# 2022-02-04 Update

This first part of this document contains a quick comparison between the 2022-02-04 version of the model and the 2021-11-10 version of the model.

Figure 1: Daily Total Volume Difference v8.3.2 2022-02-04 vs v8.3.2 2021-11-10.

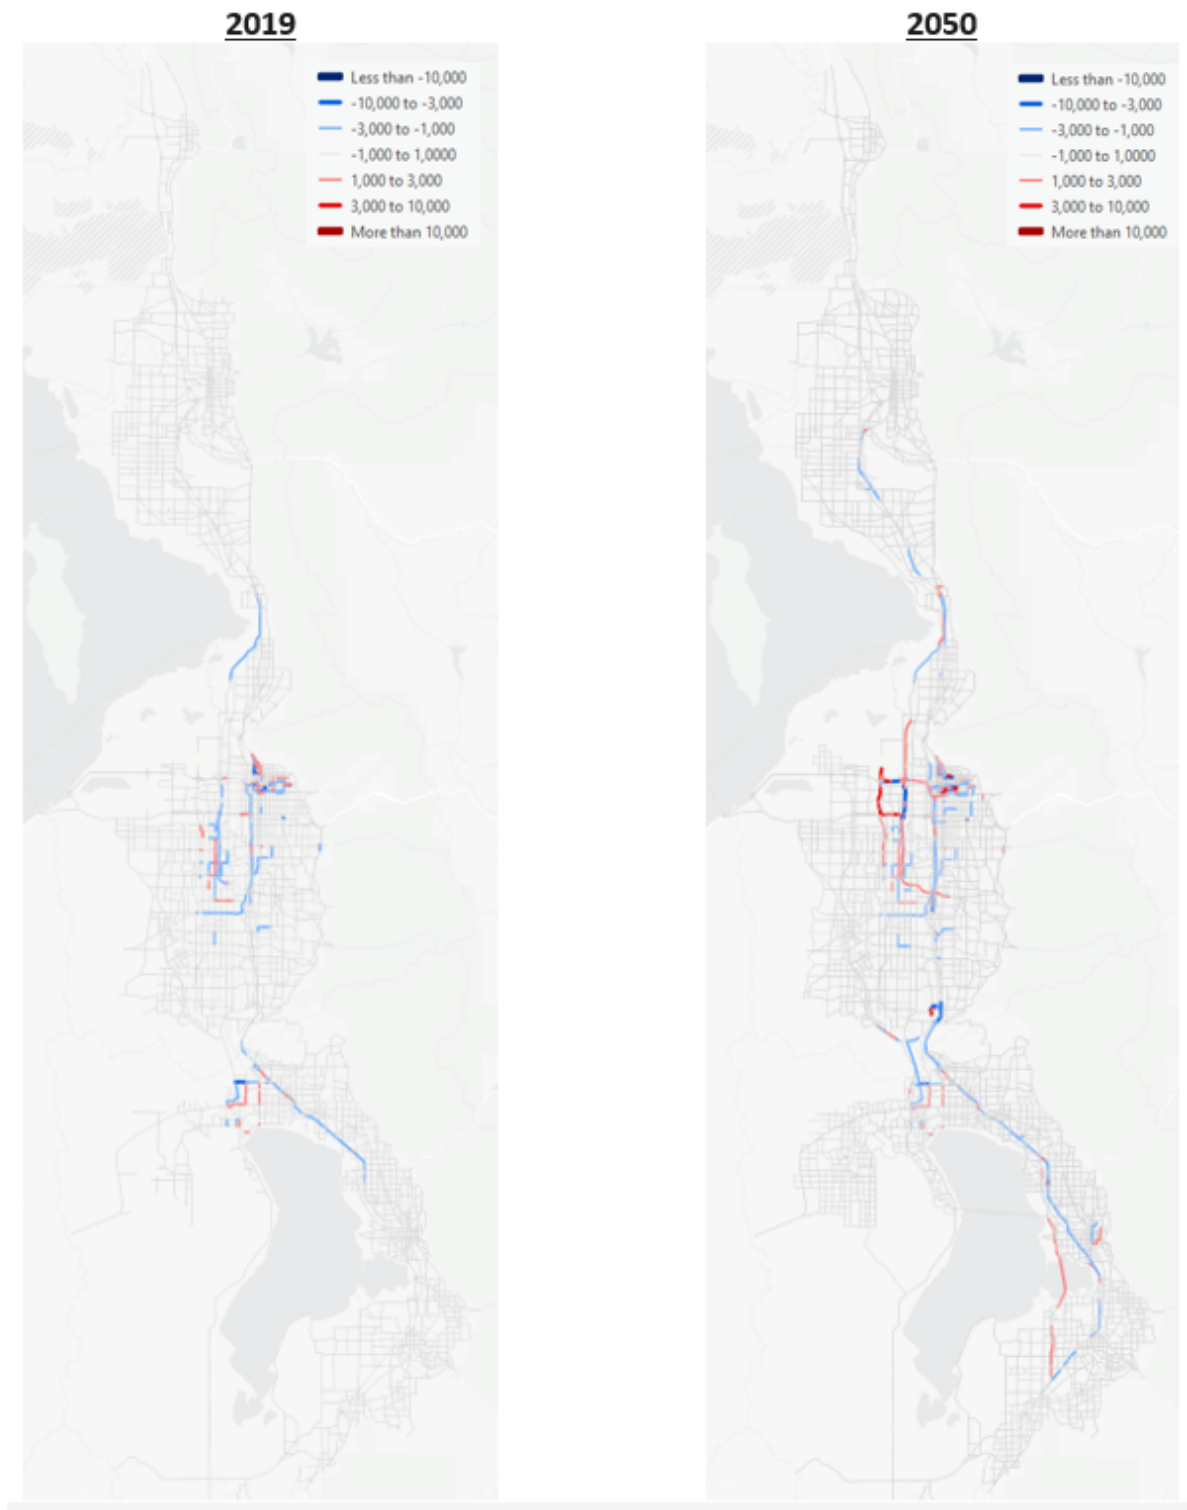
Figure 1 and Figure 2 contain a daily total volume comparison and a daily truck volume comparison. Daily total volumes are very similar between the two models. There is a slight shift of volume off of I-15 and onto parallel corridors. The largest volume shifts in 2050 are between I-215 and Bangerter Highway. Figure 1 shows one-way volumes.

Figure 2: Daily Truck Volume Difference v8.3.2 2022-02-04 vs v8.3.2 2021-11-10.

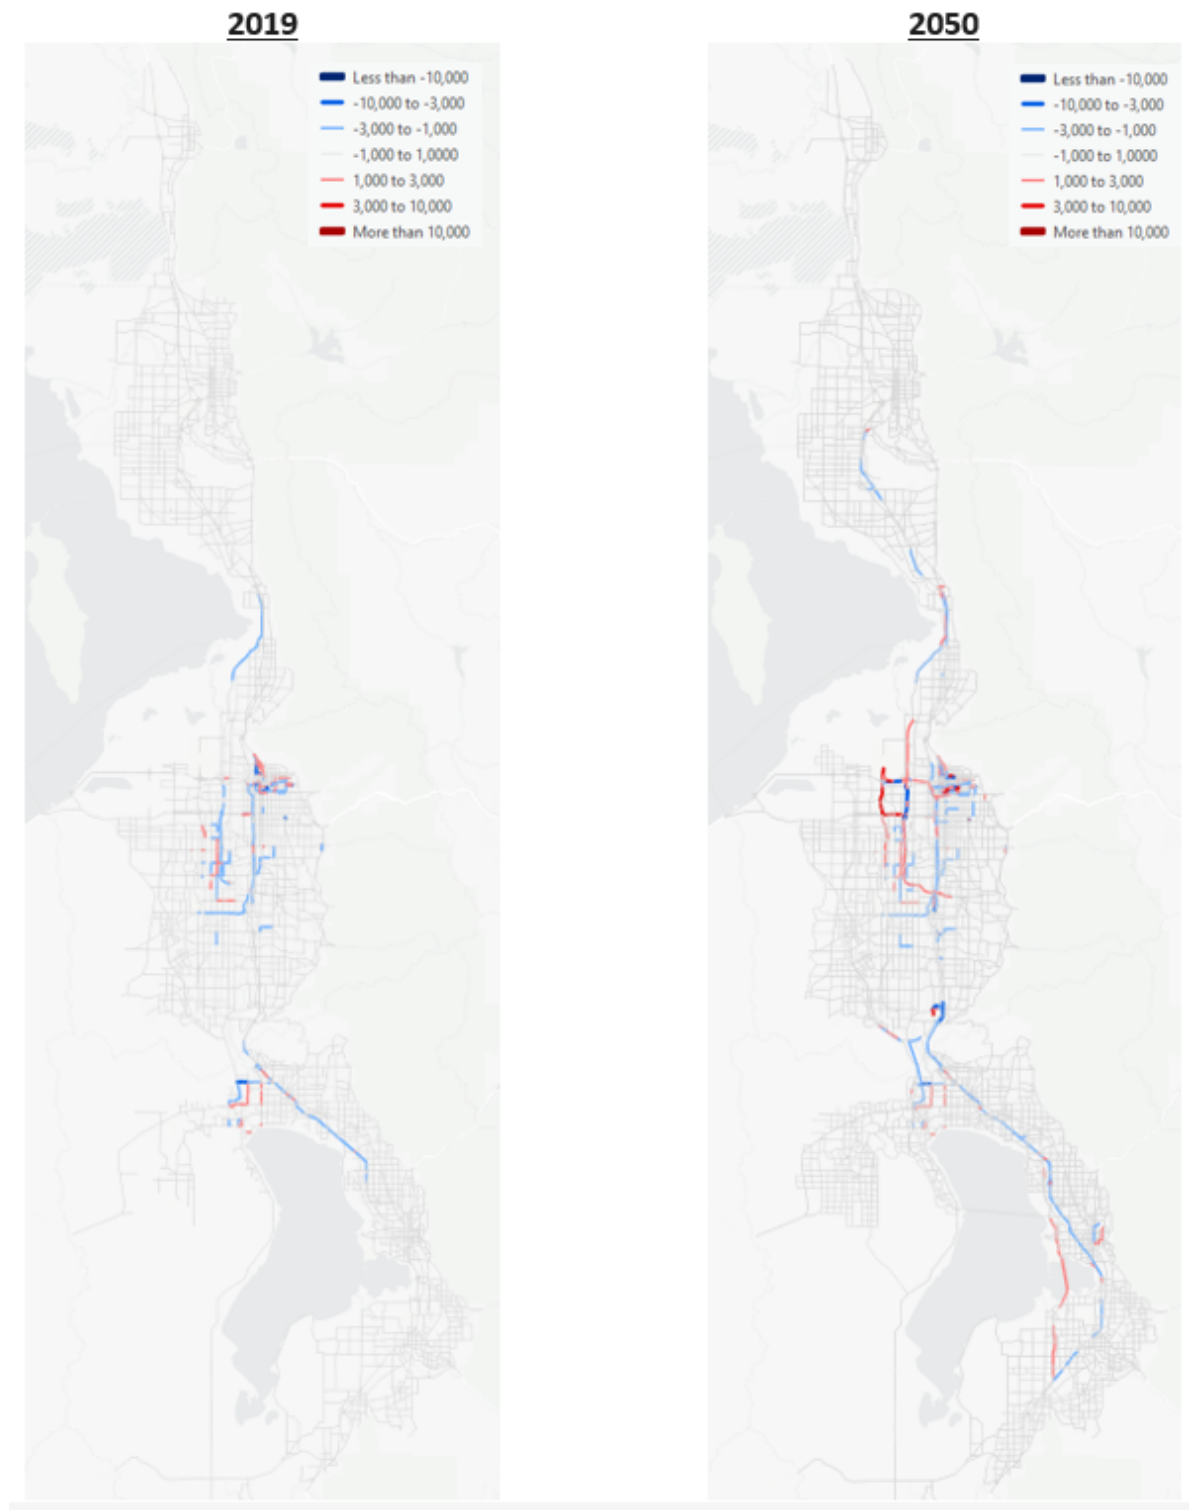
Daily truck volumes show more differences with volumes dropping between the two models. The drop in volumes is less than a 1,500 trucks per day on freeways but is widespread throughout the region. Figure 2 shows one-way volumes.
